HISTORIC AND DESIGN REVIEW COMMISSION

HDRC CASE NO: 2022-414
ADDRESS: 300 ALAMO PLAZA
LEGAL DESCRIPTION: NCB 115 BLK LOT ALL OF BLK & P-100(.209AC)
ZONING: D, H, RIO-3, Public Property
CITY COUNCIL DIST.: 1
DISTRICT: Alamo Plaza Historic District
LANDMARK: Individual Landmark
APPLICANT: Thomas Butler; Alamo Trust, Inc
OWNER: City of San Antonio
TYPE OF WORK: Construction of the Mission Gate and Lunette
APPLICATION RECEIVED: August 01, 2022
60-DAY REVIEW: Not applicable due to City Council Emergency Orders
CASE MANAGER: Edward Hall

The applicant, Alamo Trust, Inc., is requesting a Certificate of Appropriateness for approval to construct an interpretation of the Mission Gate and Lunette in Alamo Plaza as part of the Alamo Plan, and in partnership with the Texas General Land Office and City of San Antonio.

REQUEST: Alamo Mission Gate and Lunette

MISSION GATE WALLS - ENLARGED PLAN

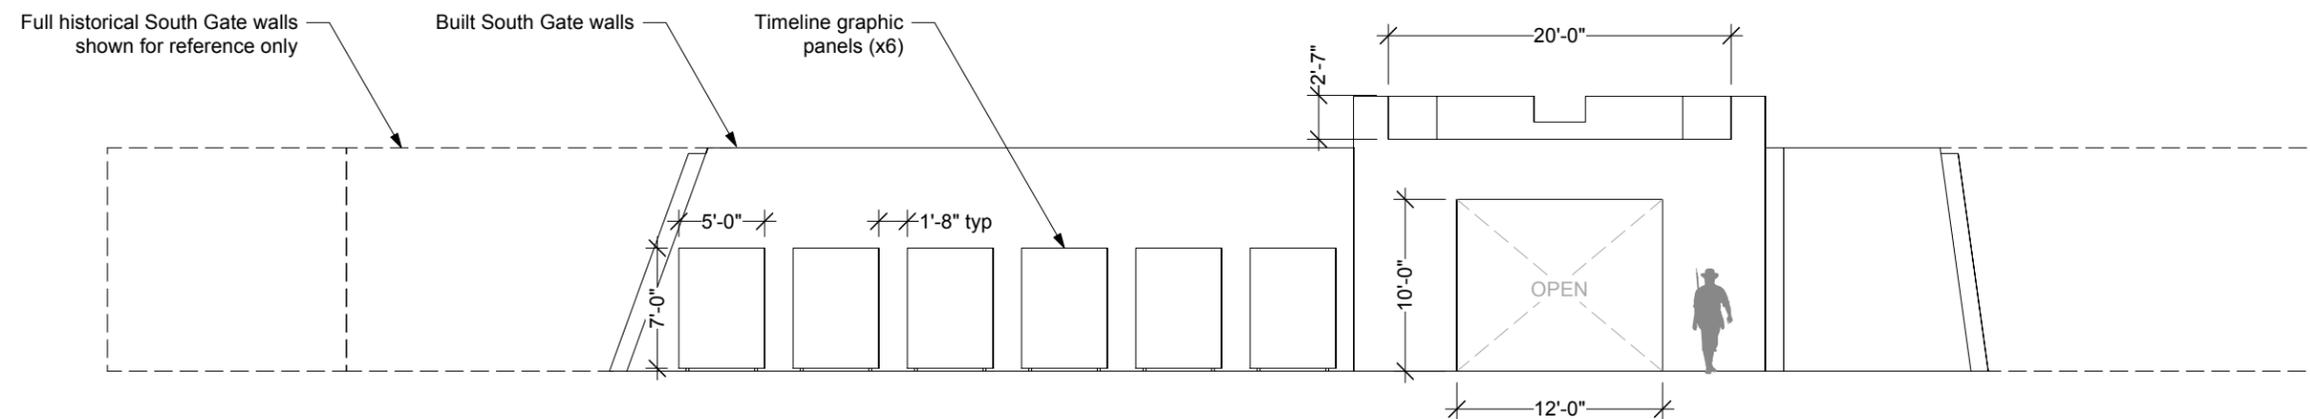
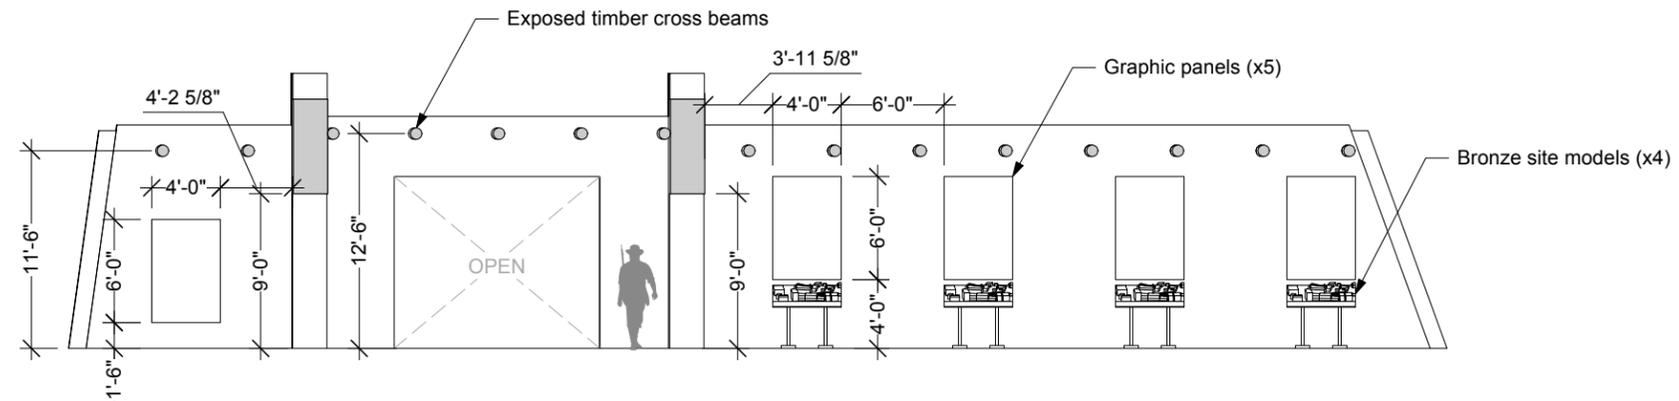
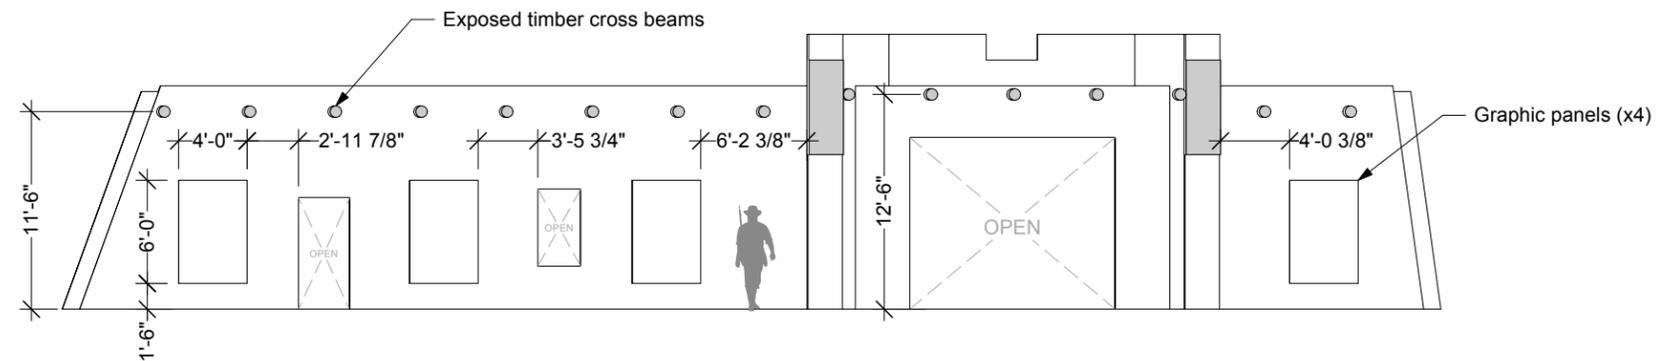
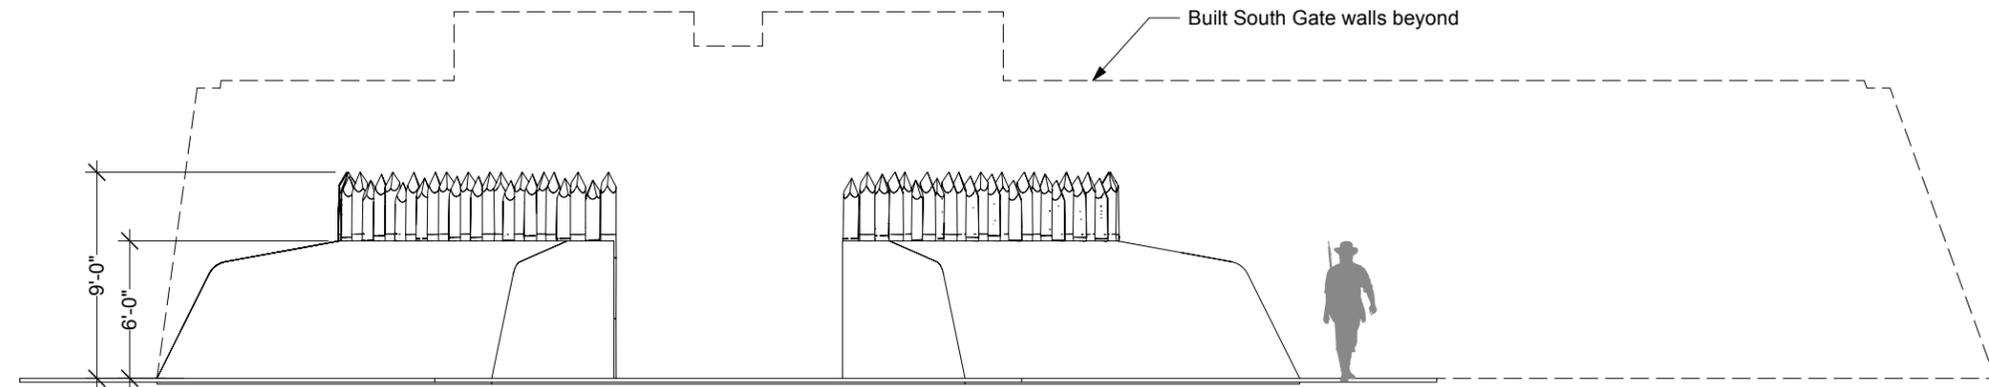
JF: Representation, not a recreation. What is the thought behind creating a faux structure, using stone and creating a somewhat “destroyed” look on each side of the gate. Why not use new materials for a contemporary interpretation?

SC: If the gate/building on either side of the gate is represented as a faux ruin, it gives concern.

CF: Will the walls be constructed of stone?

PG: The representation of the lunette is a contemporary interpretation as the original was earthwork. Some of the character of what is on site will need to be included; a mix of contemporary and recreation is needed. The appropriate balance needs to be found.

PG: Intent is a plaster finish; not a faux finish.

PG: Walls will be concrete block with plaster finish with caliche stone or another appropriate material as a finish stone.
